From: Shadab Sukri
Sent: 25 September 2024 11:28
To: Smrutika Thoti
Cc: Shama Nair; Nimisha Jadhav; Suraj Kumbhar; Rajesh Shetty; Saeed Khan
Subject: FW: Proposed FDU @Brioche Doree@Bangalore-T2

We want to add a L-shaped display in Brioche Doree outlet made at Bangalore T2. The layout is attached for your reference.

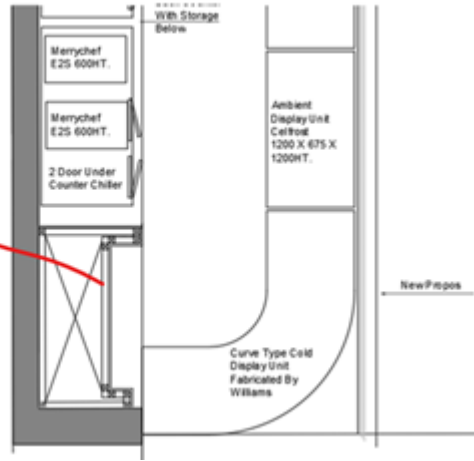
Could you provide some context?

- Also, when you add the l-shaped unit, what happens to the Grab & Go behind? Do we remove the G&G
- Also, I am assuming that the 'L' shaped unit will be ambient (i.e. Not chilled display)
- Finally, the curve shape may be problematic due to the finishes below...Can we go with all straight lines as you showed in the photograph shared

- Also, when you add the l-shaped unit, what happens to the Grab & Go behind? Do we remove the G&G – G&G removed
- Also, I am assuming that the 'L' shaped unit will be ambient (i.e. Not chilled display) – Cold Diaplay
- Finally, the curve shape may be problematic due to the finishes below...Can we go with all straight lines as you showed in the photograph shared – L shaped display added in drawing
